Suite 1, 9 Narabang Way Belrose NSW 2085 | Phone: (02) 9986 2535 | Fax: (02) 9986 3050 | www.bbfplanners.com.au

3 May 2018

# 18 Jocelyn Street, North Curl Curl Request for modification Section 4.55(1A) to DA2017/0159 for alterations and additions to existing dwelling

Figure 5 - Proposed terrace area roof plan

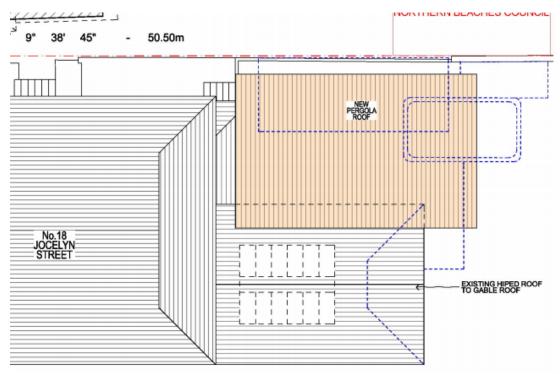
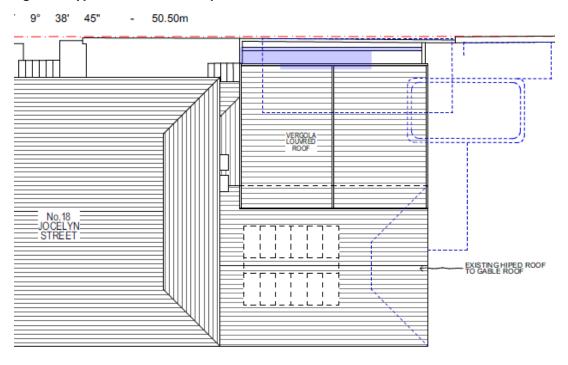
- Relocate the spa/ hot tub to the north of the approved rear terrace.
- Modify the approved rear shade structure (pergola). A Vergola with flat roof profile is now proposed.
- Extend the footprint of the approved rear terrace to the west and north and construct cabinetry and sink associated with the barbeque along the western terrace edge.
- Construct a 600mm high aluminium slat screen above the existing 1240mm high masonry wall, for length of approximately 6.760m along western boundary, adjacent to the rear terrace.
- Relocate the approved planter from the western side of the approved terrace to the northern end.
